ALAMEDA DE LAS PULGAS STREETSCAPE PROJECT

May 13, 2003

**Subject: Request for Consideration of a Larger Turn Radius at the
Proposed Bulb-out at the Corner of Avy and Alameda de las
Pulgas**

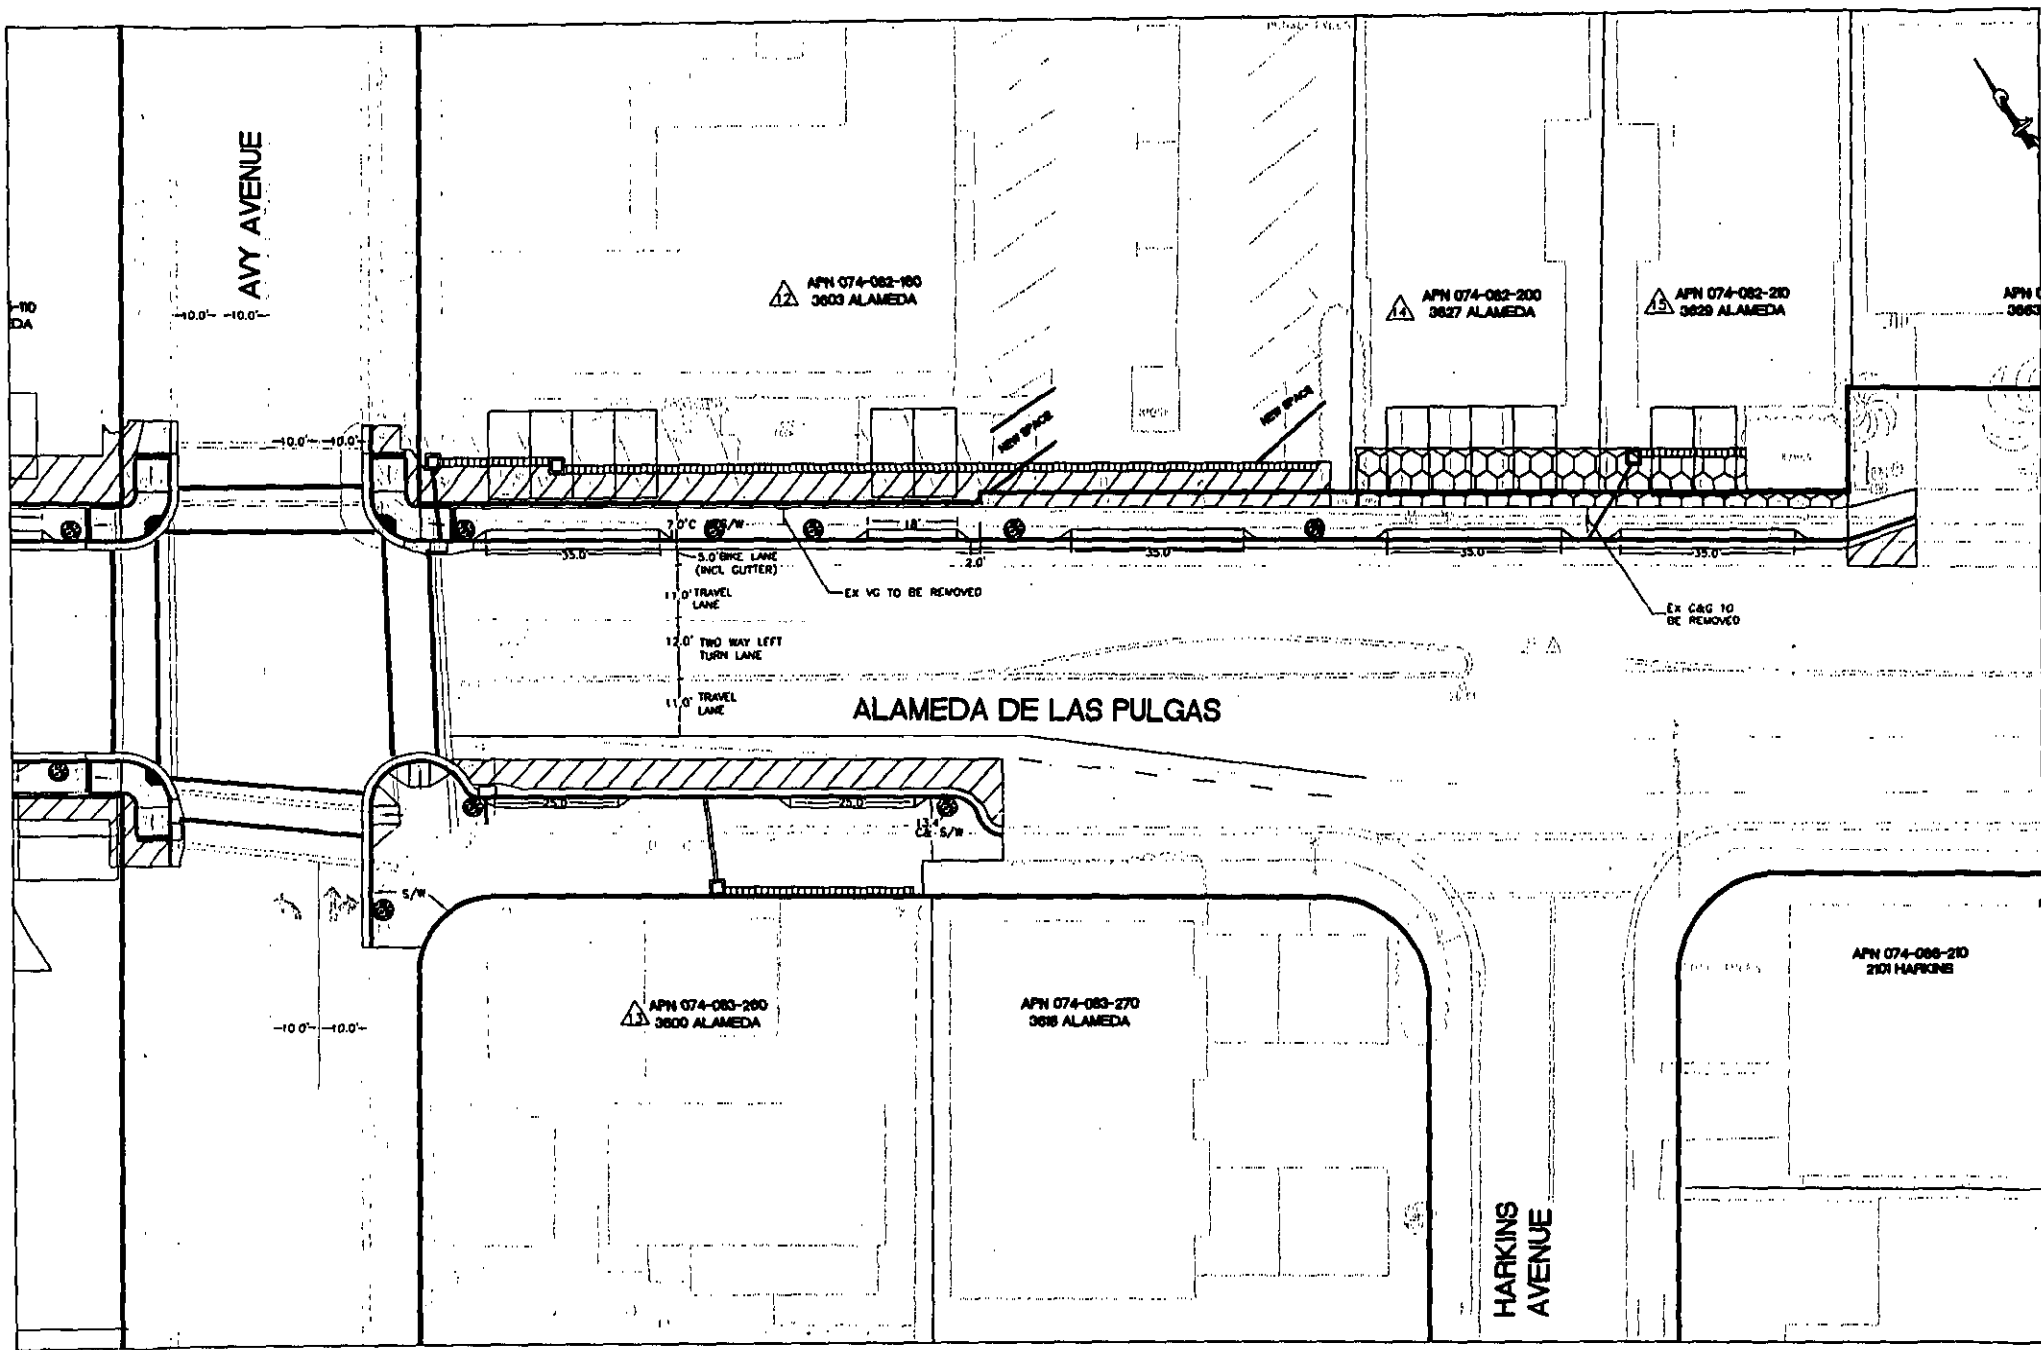
The proposed bulb-out has a much smaller curb radius (ten feet) compared to the existing curb at the southwest corner of Avy and Alameda. The proposed curb radius is also significantly smaller than the one used in the trial period. With the bulbout in place, large vehicles making a right turn from Avy onto Alameda would completely occupy the left turn pocket on Alameda (see Attachment). This would cause a hazard when the pocket is occupied with cars waiting to make a left turn onto Avy from Alameda. The above conditions, especially the inability for large vehicles to make right turns while the left turn pocket on Alameda is occupied, would cause excess back-up of traffic on Avy, especially during school peak hours, which could add to traffic congestion and diversion into residential neighborhoods.

The Menlo Park City Council urges the County to consider a larger curb radius (fifteen feet minimum) for the bulb-out at the subject intersection in order to alleviate the conditions stated above.
